**ADDENDUM NO. 2****Date of Issue: 1 February 2022**

Project: Renovations to Building 1000 Surgical Technology Lab  
Client: Horry-Georgetown Technical College  
State Project No.: H59-N085-PG  
DA Project No.: 21-106  
Prepared by: Doyle Architecture, LLC  
315 Main Street, Suite 2B  
Conway, South Carolina, 29526

SHEET:  
**M2.0**

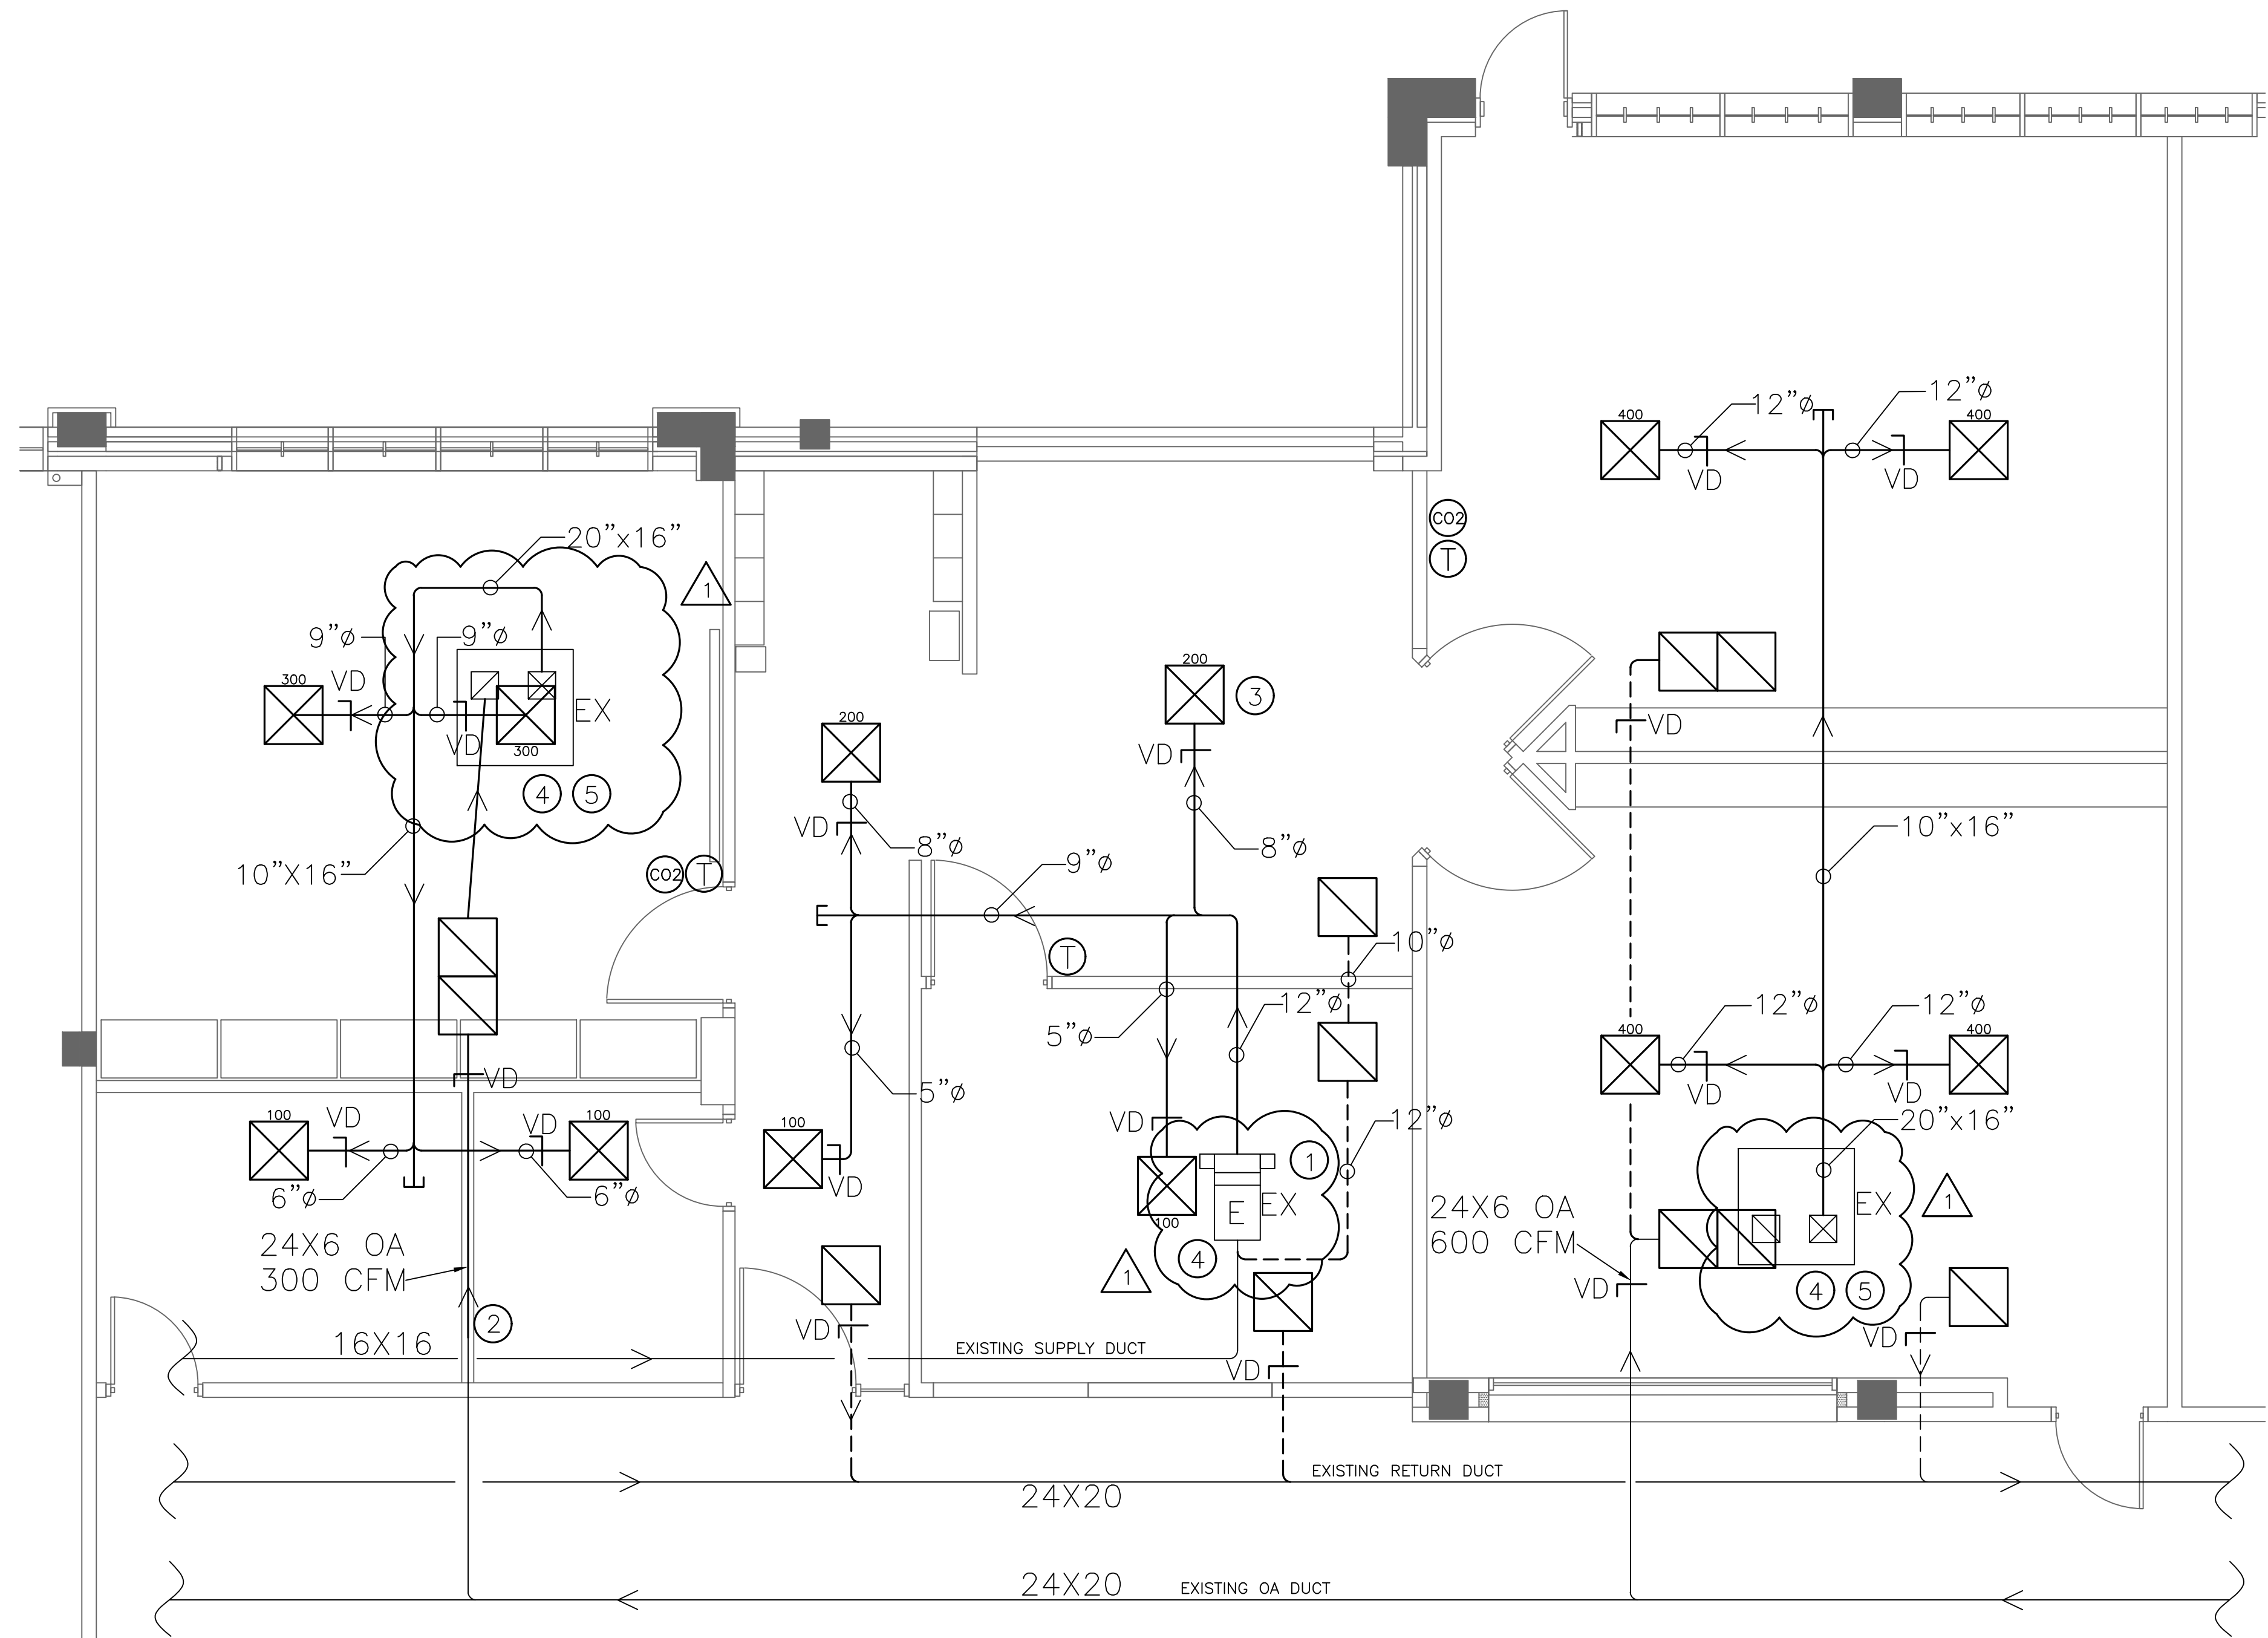
14. Sheet M2.0: Plan Key Notes
  - A. **ADD** Key Note 4 to read, “Contractor shall use Owner’s temperature controls contractor: CMI” as shown on the revised Sheet M2.0 issued with this addendum.
  - B. **ADD** Key Note 5 to read, “Existing RTU units to remain” as shown on the revised Sheet M2.0 issued with this addendum.

15. Sheet M2.0: HVAC Plan
  - A. **ADD** Key Note 4 and Key Note 5 at each RTU location as shown on the revised Sheet M2.0 issued with this addendum.

- EXISTING VAV BOX TO REMAIN FED FROM MAIN BUILDING SYSTEM
- EXTEND EXISTING 24"x6" RETURN DUCT TO NEW RETURN GRILLES
- MATCH NEW DIFFUSERS AND RETURNS WITH EXISTING
- CONTRACTOR SHALL USE OWNERS TEMPERATURE CONTROL CONTRACTOR: CMI
- EXISTING RTU UNITS TO REMAIN

SHEET:  
**E1.0**

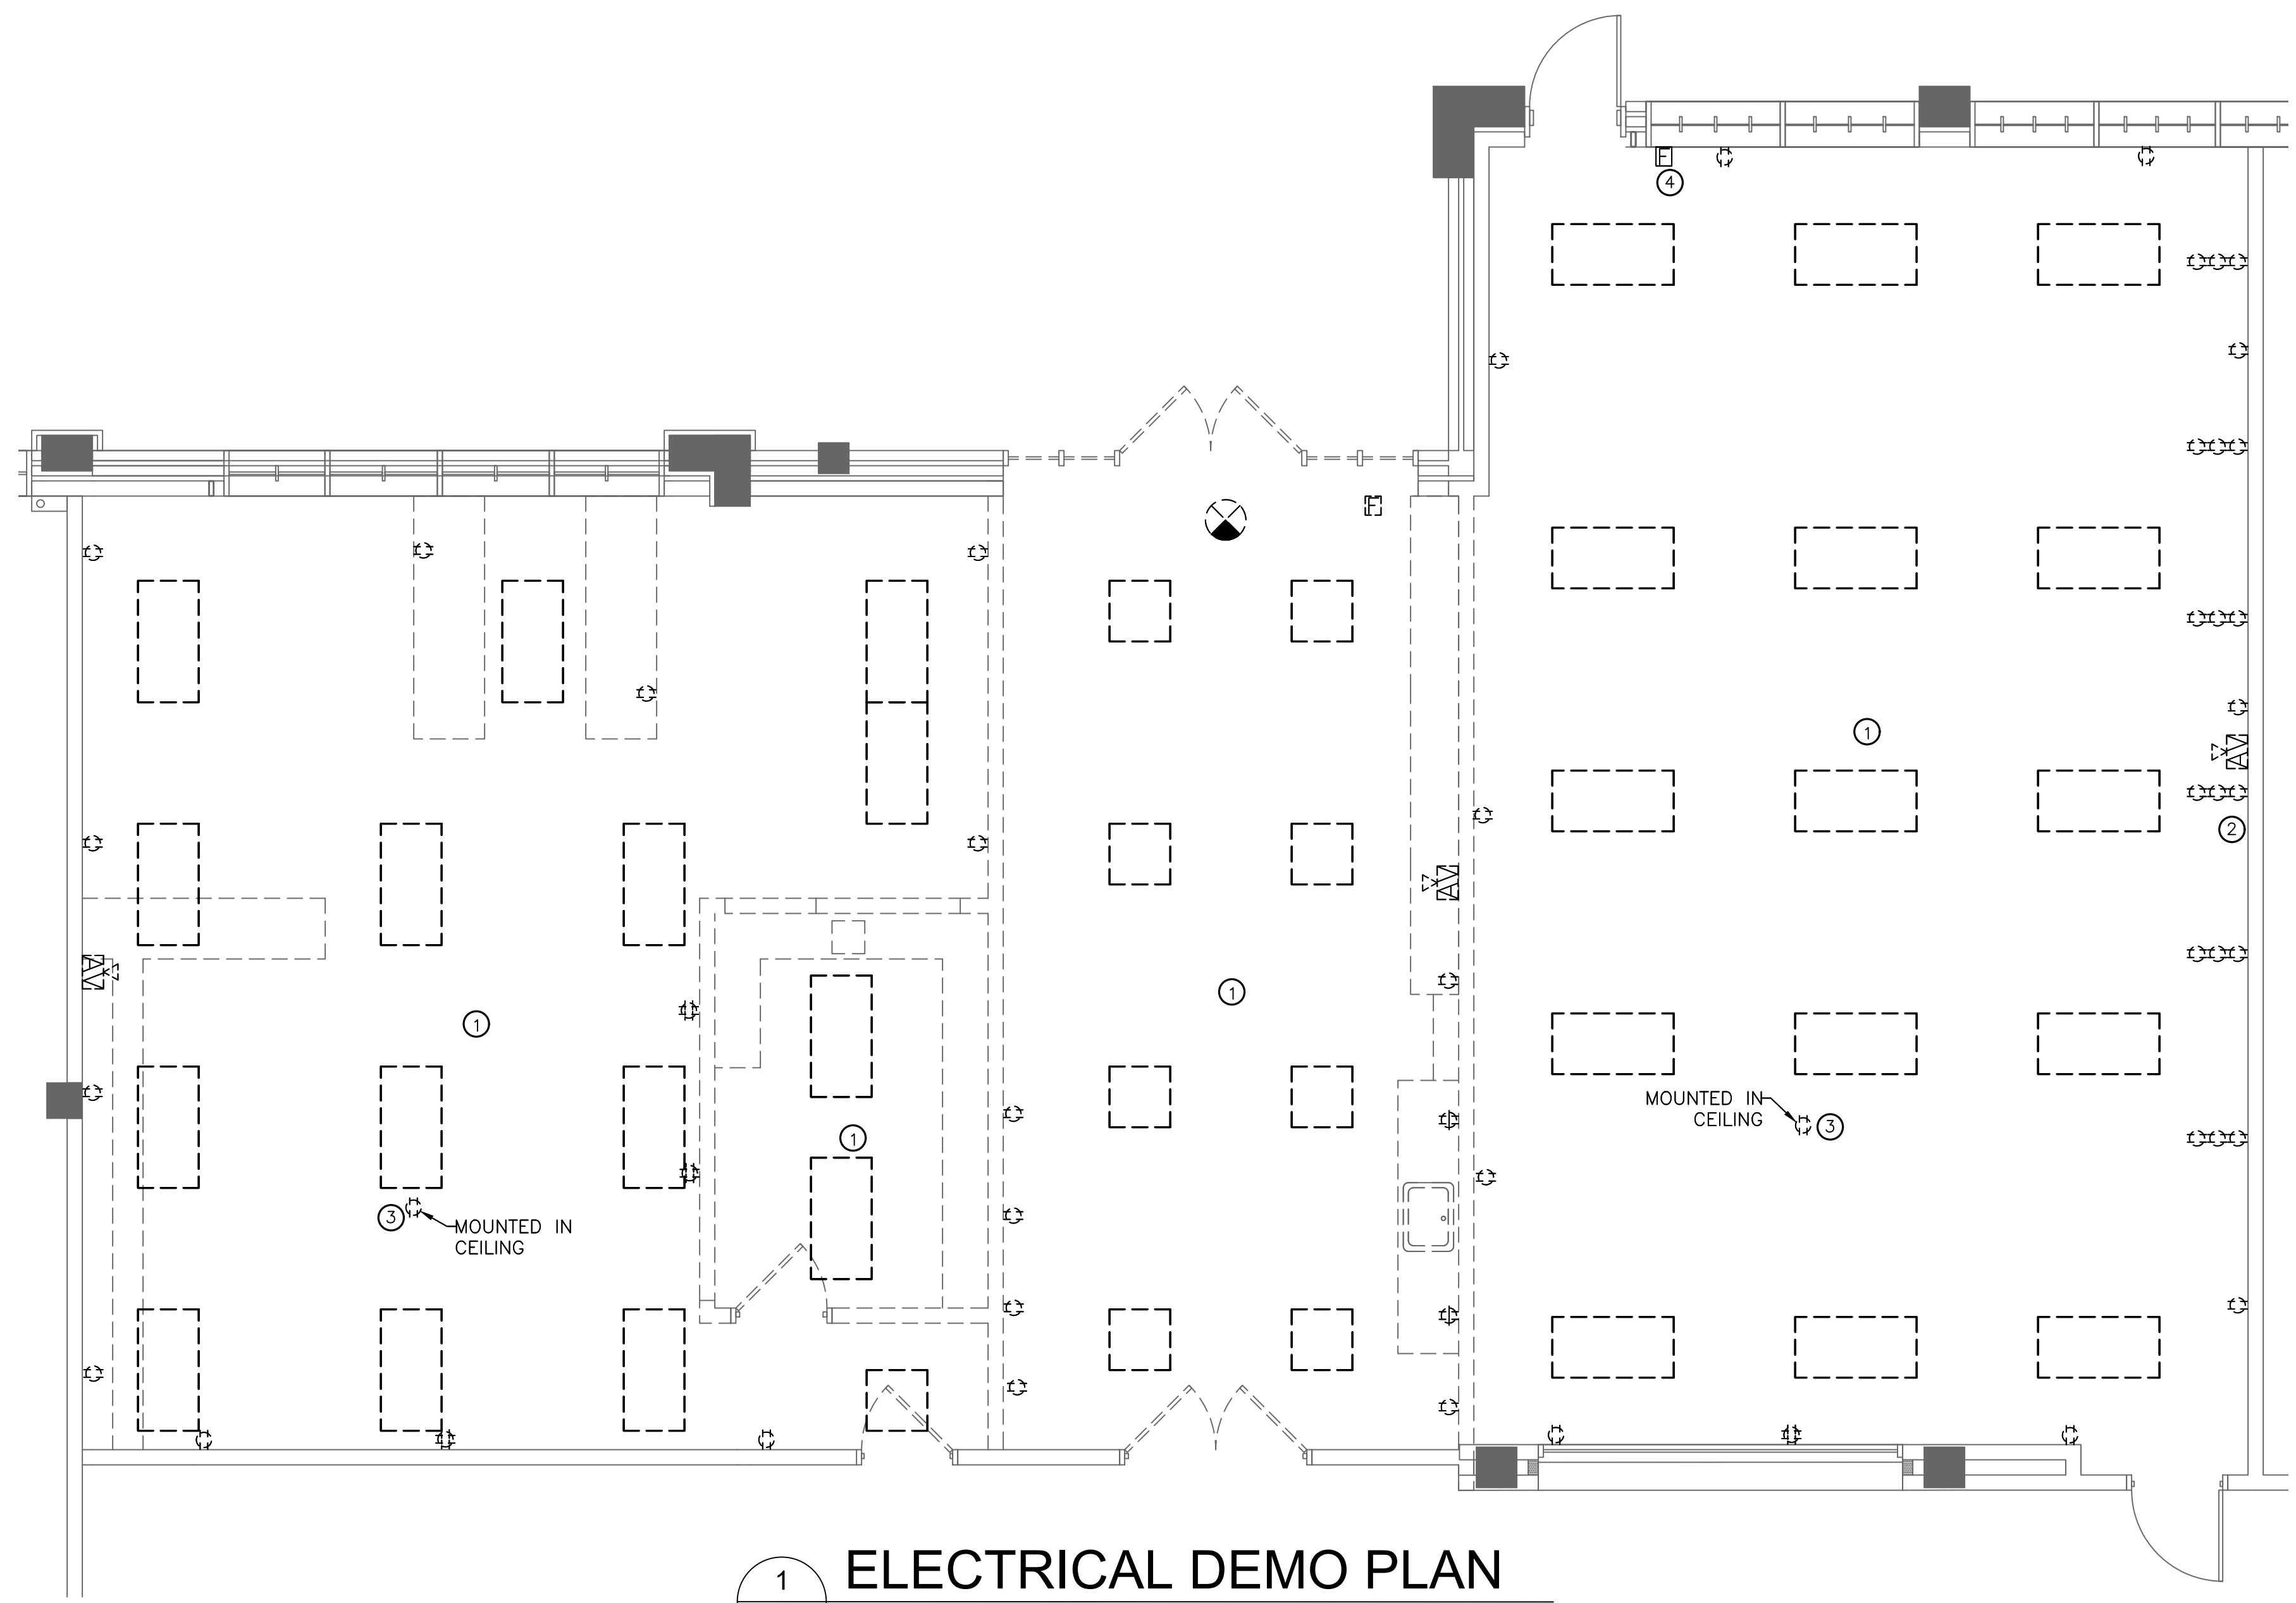
16. Sheet E1.0: General Electrical Demolition Notes
  - A. **CHANGE** Note 14 to read, “Existing panelboards: Existing panelboards are to remain energized” as shown on the revised Sheet E1.0 issued with this addendum.

- EXISTING PANELBOARDS: EXISTING PANELBOARDS ARE TO REMAIN ENERGIZED.
- REMOVE ALL EXPOSED ROMEX TYPE WIRING AND REPLACE WITH WIRE IN WIREMOLD IN VISIBLE AREAS, OR CONDUIT IN HIDDEN AREAS.
